Groundwater Application Review Summary Form

Application # G- 18721

To: Kristopher Byrd, Well Construction and Compliance Section Manager
From: Joel Jeffery, Well Construction Program Coordinator
Subject: Review of Water Right Application G-18721
Date: December 4, 2018

TO: Water Rights Section Date November 15, 2018
 FROM: Groundwater Section J. Hackett Reviewer's Name
 SUBJECT: Application G- 18721 Supersedes review of _____ Date of Review(s) _____

Stream Depletion Model

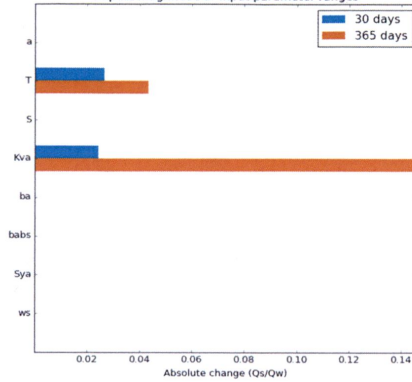
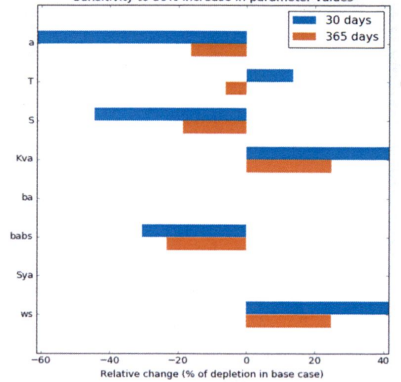
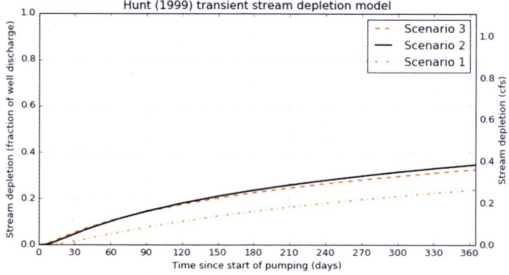
Comments: Interference was calculated for closest well/stream pair (BENT 55311 to Albany Channel). Impacts were calculated with the Hunt 1999 analytical model using parameters appropriate for a highly productive (T = 10,000 ft²/d) unconfined aquifer. Calculated impacts were approximately 5% of the pumping rate after 30 days of pumping (see attached model form).
